2023FA04, Rev. A
November 02, 2023
Product Code(s): 65
Page 1 of 3

SUBJECT: Output Shaft Yoke/Flange Retaining Bolt Torque Specification Increase

MODELS AFFECTED: B3400 R xFE™, B400 R

Figure 2.

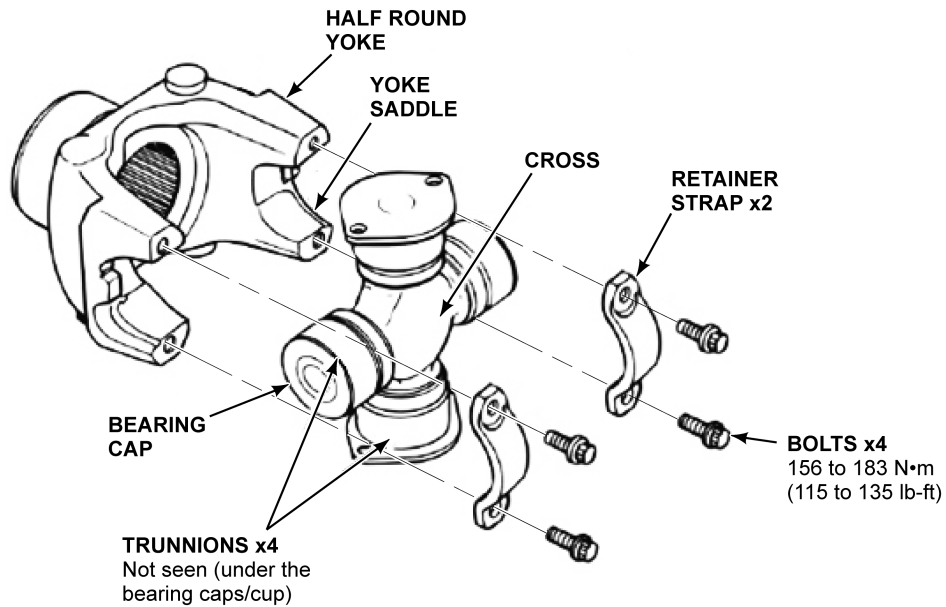
5. **Torque output shaft yoke/flange retaining bolt P/N 29535219 to new specification; 130 N·m (95 lb ft).**
6. Clean original paint mark and reapply paint mark to the output retaining plate and output yoke bolt with one continuous mark.
7. Reinstall driveline and secure u-joint to transmission output yoke with new straps and bolts from hardware kit.
 - Follow manufacturer's torque procedure and specifications. Refer to [Figure 2](#).
 - Prior to lowering bus from lift, mark transmission nameplate with paint pen to indicate output shaft yoke/flange retaining bolt torque has been verified.
